ATTACHMENT 5.03

Response to AER decision on replacement expenditure

Prepared by: Endeavour Energy

January 2015

Figure A-9 Repex across the NEM normalised for customer density

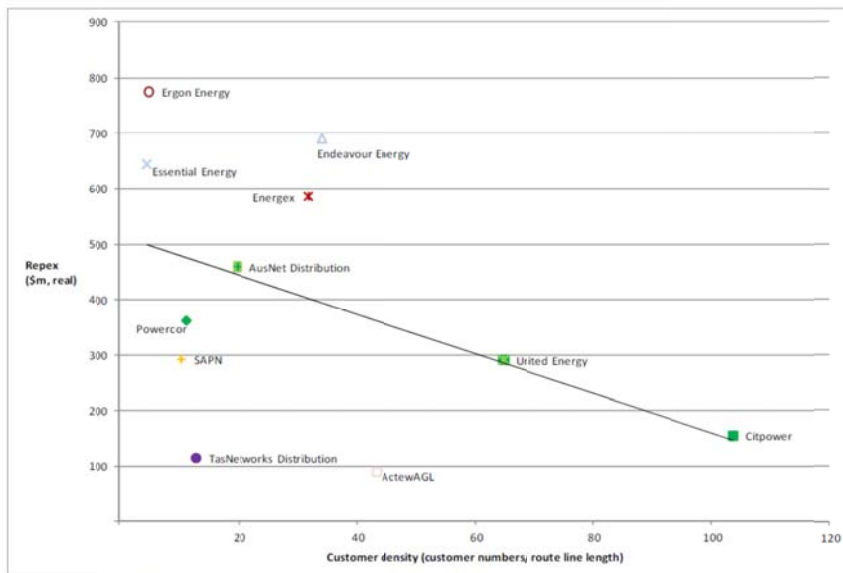
“Endeavour Energy compares unfavourably under both density measures. Further, these measures suggest that predominately rural based networks incur higher repex than urbanised networks. When considering whether a network is relatively rural or urban we have also taken into account the length of lines in commission by feeder type. That is, the length of overhead conductors and underground cables installed on CBD, urban, rural short and rural long feeders. The predominately rural networks have a high proportion of assets on long rural feeders. However, Endeavour Energy has only 0.5 per cent of its assets on rural long feeders (compared to around 50 per cent for the predominately rural networks).¹⁰”

Endeavour Energy categorically rejects this benchmarking analysis and the AER’s conclusions. This analysis fails a considerable number of the Productivity Commission’s six criteria for benchmarking which the AER adopted as benchmarking principles in their guideline.

Specifically, these measures do not account for the significant number of operating and environment factors that may impact on the results. Furthermore, the data relied upon is not comparable or prepared on a similar basis across the DNSPs included nor is the dataset of a sufficient size to form reliable conclusions with. In spite of this, the AER assumes it is measuring efficiency despite the apparent low explanatory power of the variables modelled and unquantified, unknown number of unaccounted factors. In light of the known limitations of this analysis and its prevalence in the AER’s repex assessment, we consider the following benchmarking principles have been breached (for repex benchmarking):

Figure A-8 Endeavour Energy’s repex including overheads historic actual and proposed for 2014–2019 period (real \$ million June 2014)

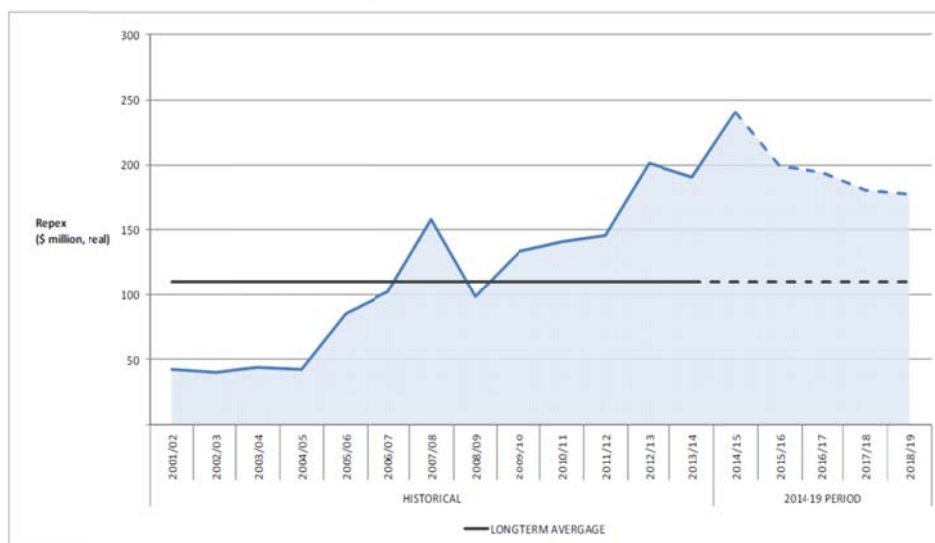
“Figure A-8 shows that Endeavour Energy’s proposed forecast repex of \$992 million (\$2013-2014) for the 2014–19 period significantly exceeds its long term average. This is a 55 per cent increase above its long term average repex and a 22 per cent increase in the amount actually incurred in the most recent regulatory control period.”¹¹

This average covers the 2001-2019 period to support an asset age profile the AER considers reasonable between the 2006-13 period. This mismatch is illogical, the AER should match the cost average to the age profile the AER considers acceptable. The long term cost average covers a significant period of under-

investment (2001-2006) prior to substantive industry changes (licence conditions). Irrespective of this, there is no consideration or demonstration of why the long term average is a valid benchmark and measure.

We have not revised our proposal to conform to such an average because it will result in unsustainable and unsafe outcomes. This is a simple measure that is significantly less refined than our top down WARL. The AER have failed to consider the implications of this average and justify its reasonableness.
